**Remarks**

The present invention is a humidifier in a gas supply apparatus for a polymer electrolyte fuel system comprising an inlet pipe through which reactant gasses are supplied from a reactant gas reservoir, a reactant gas flux regulator for adjusting a flow rate of supplied reactant gasses, a reactant gas supply pipe for supplying humidified reactant gasses to a fuel cell, a pressure regulator for adjusting pressure of reactant gasses inside the fuel cell, a coolant regulator for cooling the fuel cell, a fuel cell temperature regulator for adjusting temperature of the fuel cell, and a humidifier for humidifying the reactant gasses for a polymer electrolyte fuel system. The humidifier comprises in an embodiment of the invention a humidification vessel 20 to which is connected a reactant gas inlet pipe 24 for supplying reactant gas thereto, a water inlet pipe 30 for supplying water thereto, and a reactant gas supply pipe 24 for supplying the humidified reactant gasses to the fuel cell; and a sprayer 26, which is installed in the humidification vessel, for spraying the reactant gasses and water supplied to the humidification vessel.

S.N. 10/028,663

**AMENDMENTS TO THE DRAWING

Fig. 1

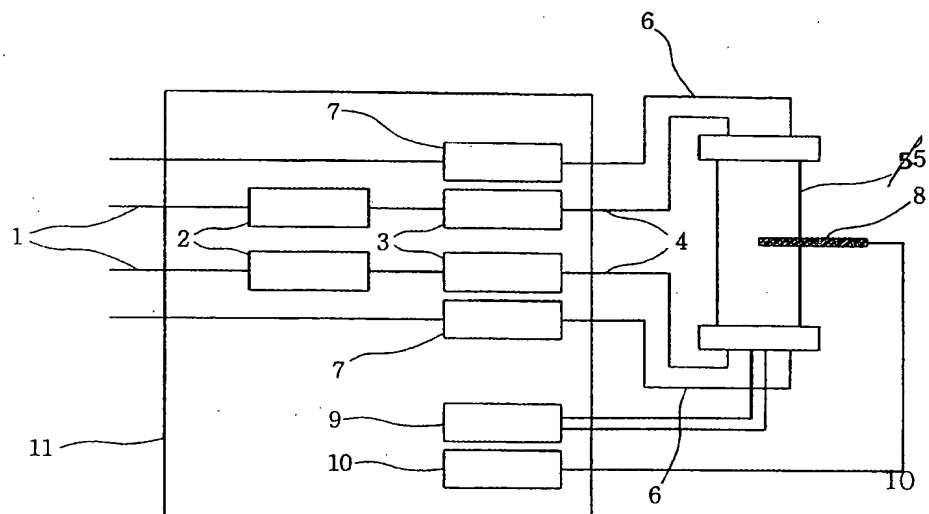
The drawings stand objected to regarding informalities noted in sections 1 and 2 of the Office Action. The Specification has been amended to correlate the reference numbers used in the drawings with the Specification.

Fig. 1 has been amended to replace reference numeral "55" with "5" as marked in red. Replacement drawings are attached hereto.

Please replace drawing sheet [0011] including Figs. 1 and 2 with the amended sheet attached hereto. An annotated sheet showing the change made is also attached.
